**ROYAL COMMISSION OF INQUIRY INTO BUILDING
FAILURE CAUSED BY CANTERBURY
EARTHQUAKES**

THE CTV BUILDING COLLAPSE

**STATEMENT OF EVIDENCE OF WILLIAM HOLMES
IN RELATION TO THE CTV BUILDING**

Review of Structural Alterations in 2000 to Add New Stair from Level 1 to Level 2 by William T. Holmes

Figure 1 Showing plan of vertical bars in end of south wall and drilled holes from trimmer beam

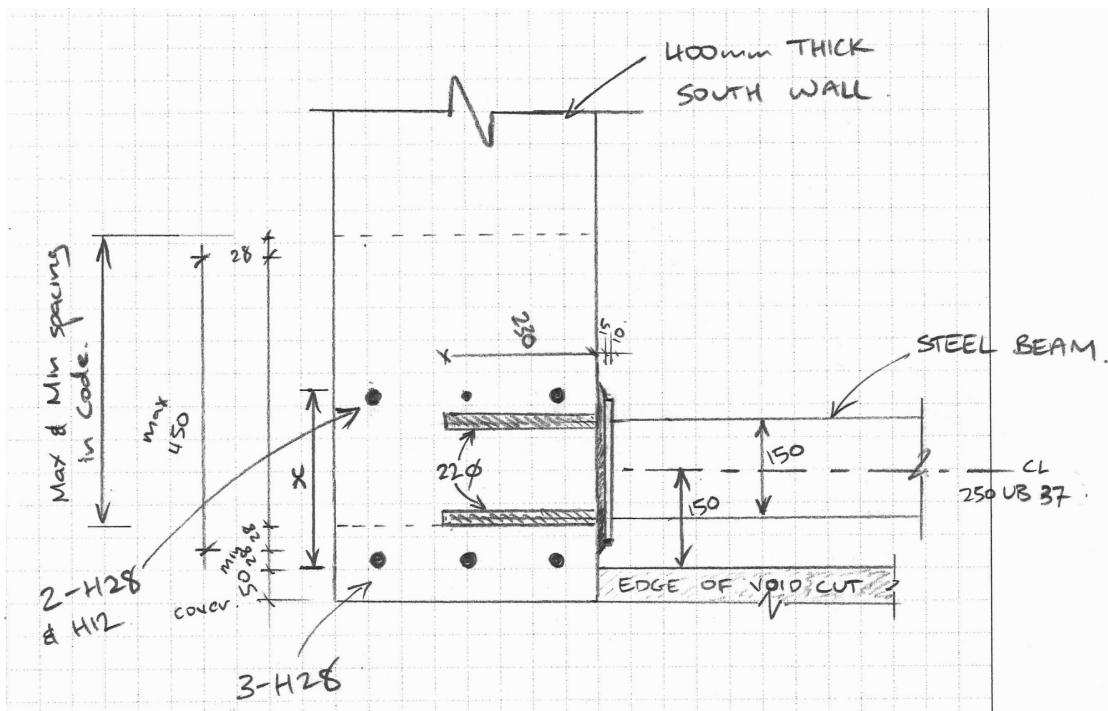
19. The locations of the drilled holes for the beam connection bolts shown in Details 4 and 6 of the Falloon and Wilson drawing are placed to avoid top and bottom steel of the beams and can be assumed to be unaffected by the drilled holes.
20. The potential effect on the vertical bars is less clear, as shown in Figure 1 (below). The holes for the trimmer beam connection bolts would apparently miss the outer 2-H28 vertical bars. As sketched, the inner bolt will also miss the inner set of 2-H28 and 1-H12 bar. However, the dimension X on the sketch is not specified on the structural drawings and was drawn in Figure 1 to scale as shown on the drawings. Therefore, depending on the exact location of the shear wall reinforcing bars, the holes for installation of the trimmer beam connection bolts could have hit the shear wall vertical bars.

24. Finally, there is no evidence that the collapse was initiated by premature yielding of the south wall in the east-west direction.
25. I have therefore concluded that the vertical flange reinforcing was not cut by the installation of the western trimmer beam and therefore this installation had no effect on the seismic performance of the building.

**NEW FLR OPNG FOR STAIR
PARTIAL FIRST FLR FRAMING PLAN
DETAILS**

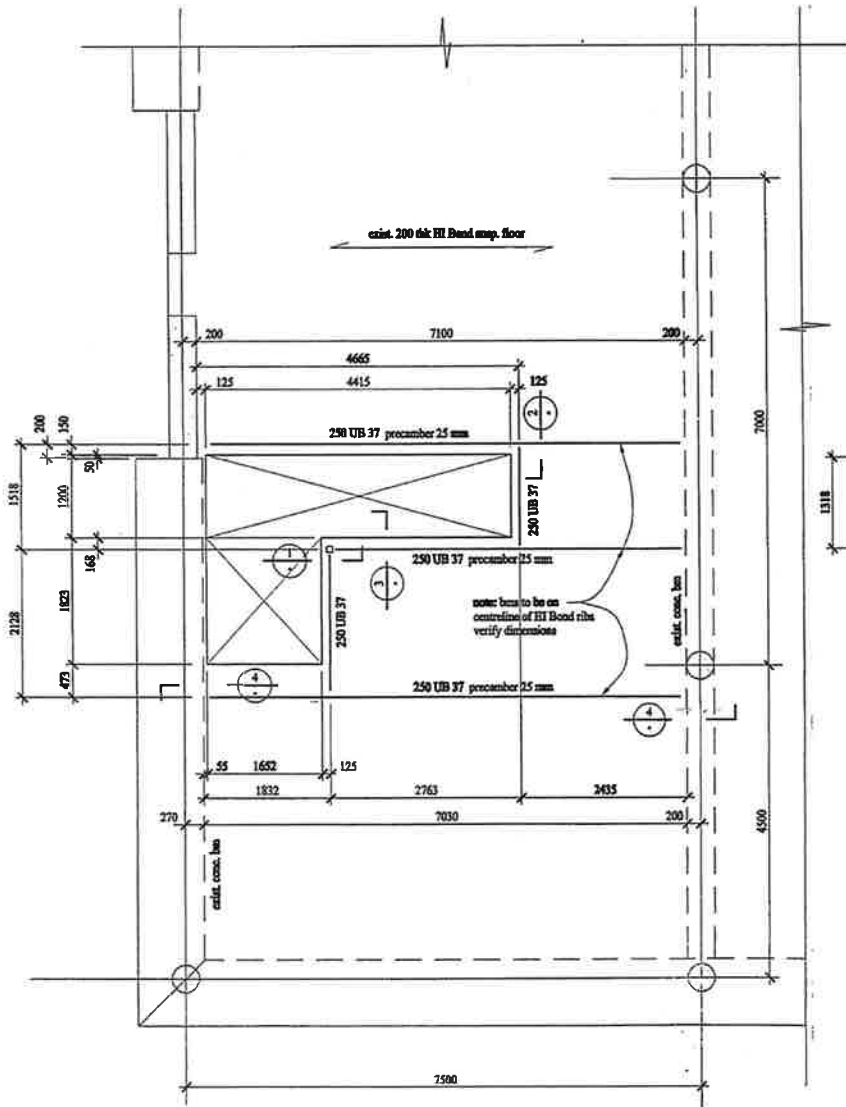
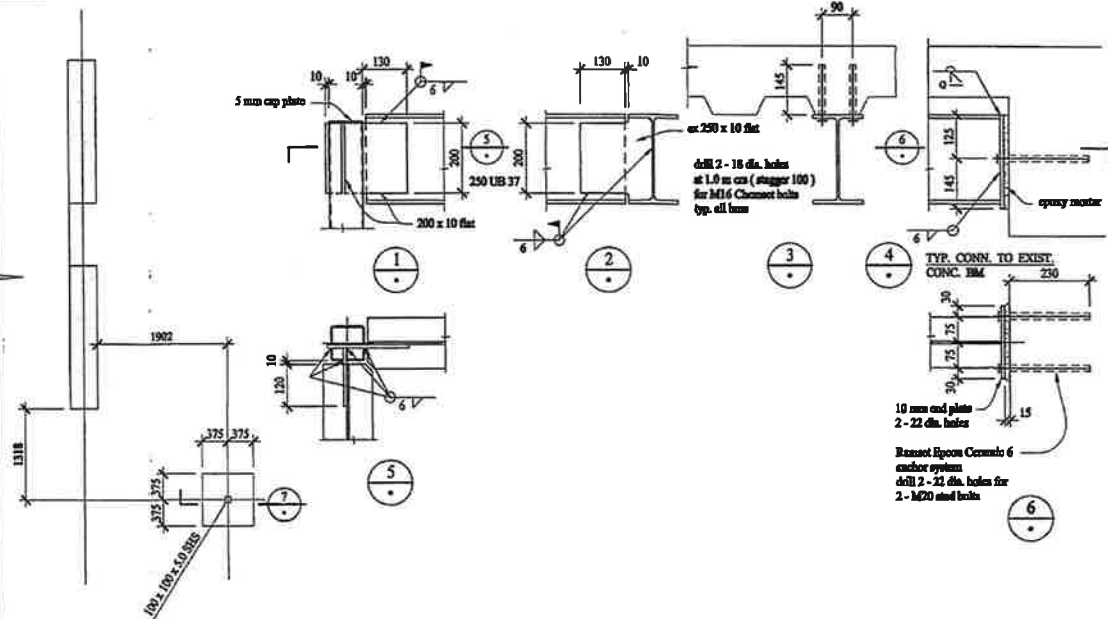
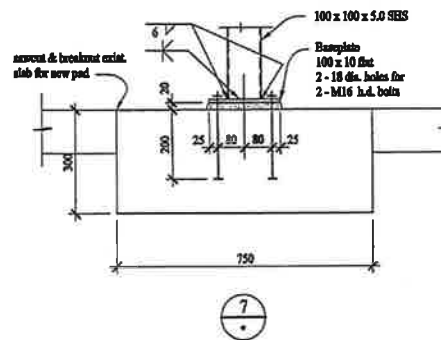
1. The Royal Commission has asked me to review the penetration cut in the Level 2 floor diaphragm at the south end of the CTV Building (**the Building**) in 2000.

2. In preparing this review have referred to the drawing submitted to the Christchurch City Council for this work by Falloon and Wilson [**BUI.MAD249.0151B.2**]. I have also referred to the original structural drawings and calculations for the Building.

4. Seismic shear to the shear wall on line 1 (**the coupled shear wall**) is transferred from the Level 2 floor slab to the wall through direct connection along the wall plus the perimeter beams on line 1 acting as collectors. The total length of this shear transfer is essentially the full width of the building from line A to line F, 30250 mm. The length of slab removed was 3023 mm or about 10% of the total length. I note that 10% is the current limit for alterations without analysis in the current US code-IBC para 3403.2.3.2.

5. Based on the length of the slab, it is most likely that 5-H12 starter bars ($A = 565 \text{ sq mm}$) were removed plus the mesh for the length of the penetration (3023 mm). It could be argued that the 2 connections of trimmer beams to line 1 added a total of 4-M20 bolts ($\text{Area} = 1256 \text{ sq mm}$) connecting the slab to line 1 as well; these 4 M20 are not included in the calculations.

26. It should be noted that the connection of a trimmer beam with drilled-in dowels at the end of a major shear wall should have included a note to carefully monitor drilling and avoid cutting of bars.

Figure 109 - Line 1 South Wall remnants (top) E1 Level 1 to 2; (Bot) E2 Level 2 to 3.

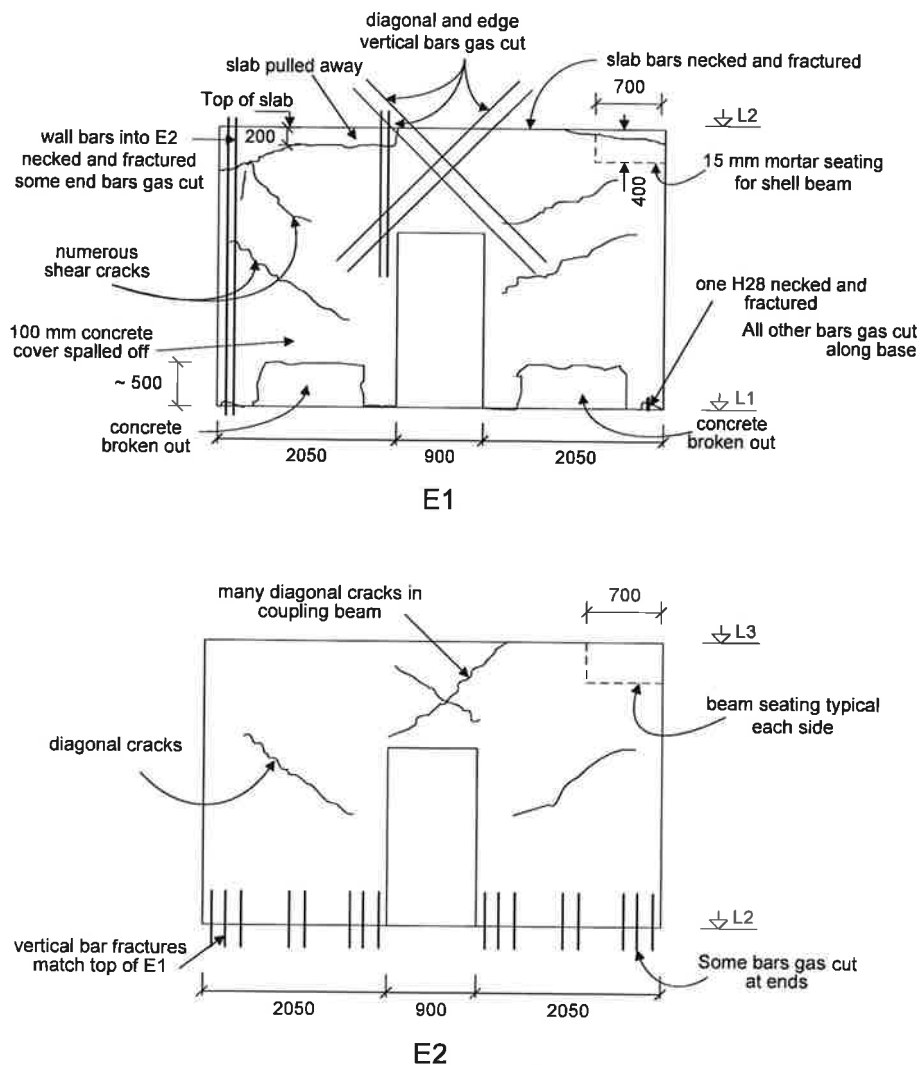
21. However, sketches of the south wall remnants in appendix C of the Hyland report do not show any indication of heavy cracking or premature yielding of the wall at the location where a cut would have been located (top right of the bottom figure in Figure 109 [BUI.MAD249.0189.213]). In fact, the sketches of the south wall indicate that the south wall was not heavily loaded in the east-west direction, either due to failure of one or more levels of drag beams on line 1, or due to early initiation of collapse elsewhere.

Figure 13

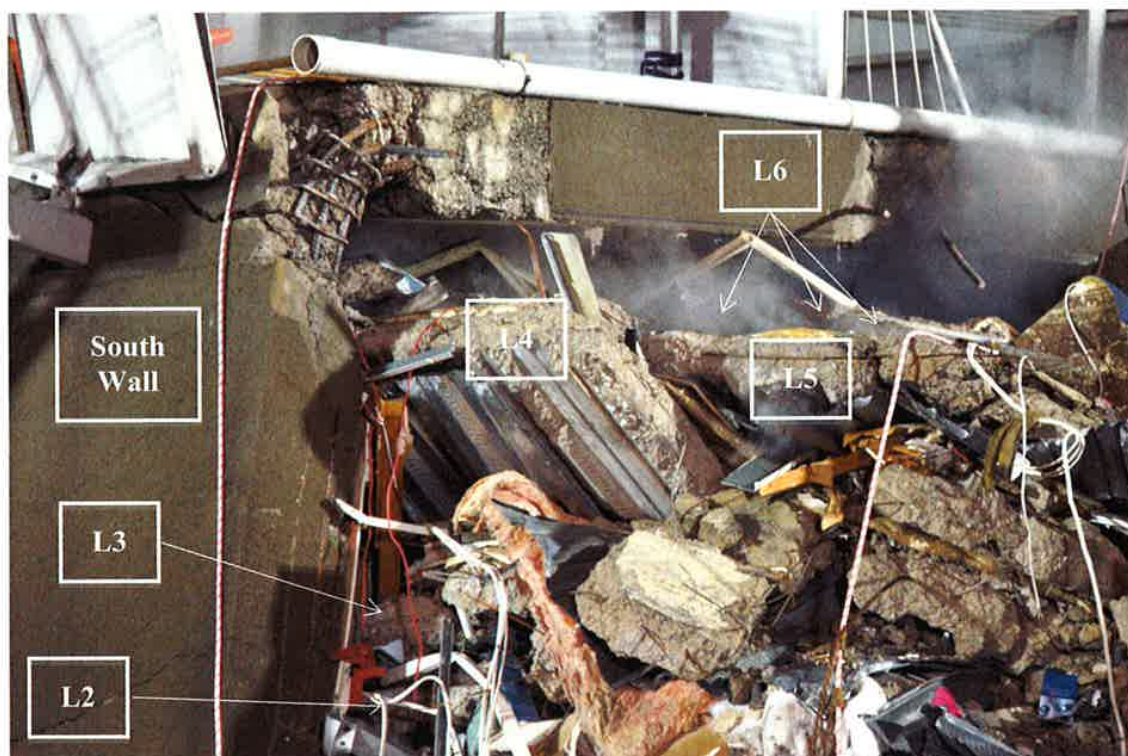
22. Figure 13 of the (First) Statement of Evidence of Robert Heywood evidence shows almost the exact location of the connection of the trimmer beam connection to the South Wall and the bars are intact [WIT.HEYWOOD.0001.42]. Unfortunately, the inner 2 bars cannot be seen.

Figure 9 Steel trimming beam: Level 2, south-east corner of the Building

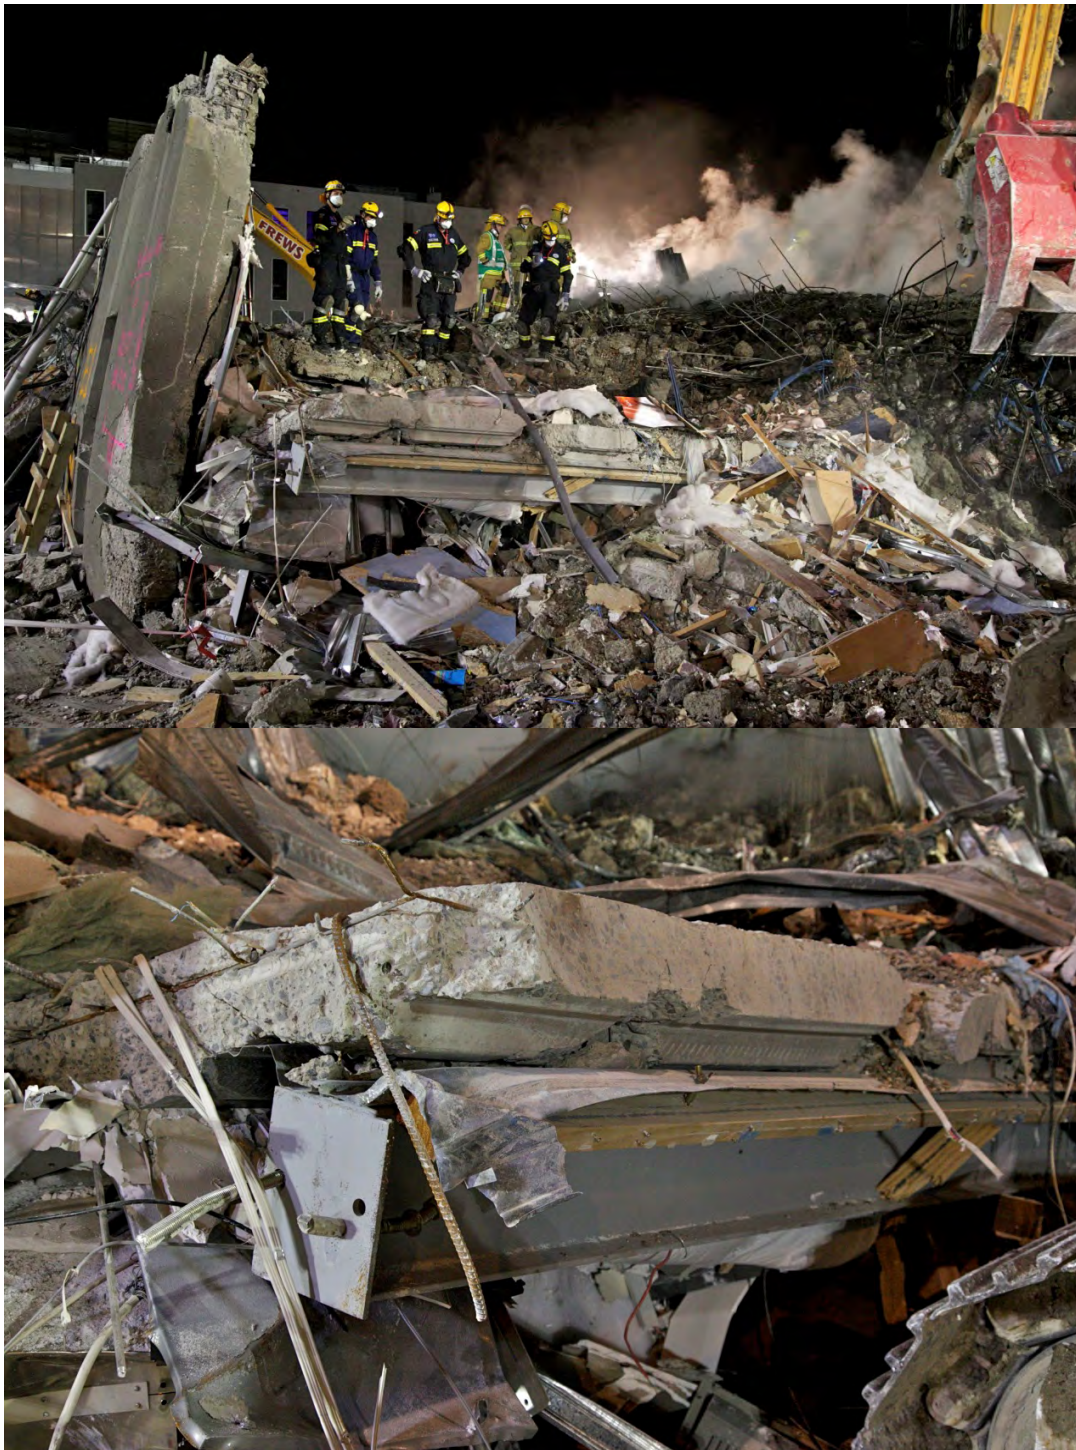
23. Most significantly, Figure 9 of the Second Statement of Evidence by Robert Heywood [WIT.HEYWOOD.0002.13] clearly shows the western trimmer beam and its connection after the collapse. The trimmer beam had pulled out of the wall. The eastern bolt, nearest the camera in the bottom photograph, has been moved from its original location and installed slightly to the west and below the original position that is identified by the hole in the mounting plate. This indicates to me that the original hole in fact hit reinforcing and the hole was moved and the bolt installed in the alternate position, free of the reinforcing. Such changing of the hole location to miss reinforcing is common practice among knowledgeable contractors.
